UNITED STATES PATENT AND TRADEMARK OFFICE

APPLICATION NO.	FILING DATE	FIRST NAMED INVENTOR	ATTORNEY DOCKET NO.	CONFIRMATION NO.
10/647,877	08/25/2003	Scott H. Carr	13976	3182

Office Action Summary

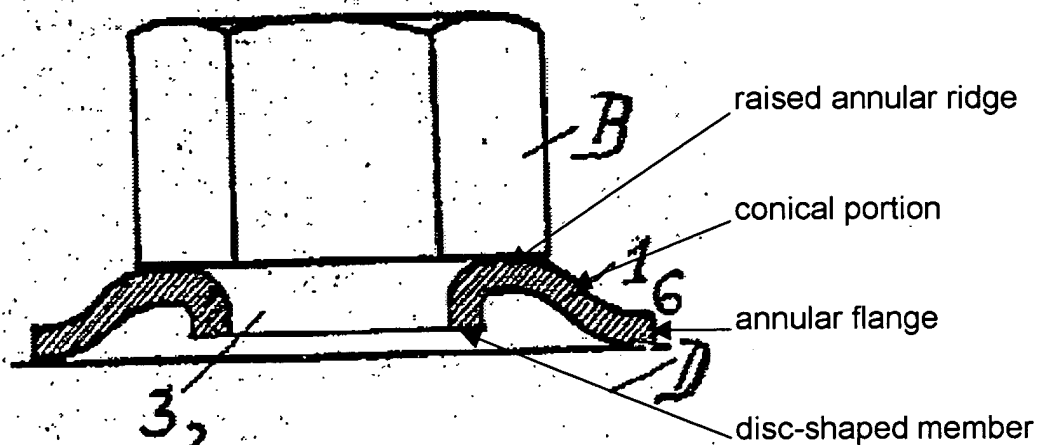
Claims 13 is rejected under 35 U.S.C. 102(b) as being anticipated by Märtens (US 1,320,259). In the embodiment of Fig. 6, Märtens discloses a washer comprising the portions as shown in the figure below wherein a "grounding screw" engages the ridge portion which would be capable of being tightened to urge the disc shaped portion into contact with a grounding terminal.
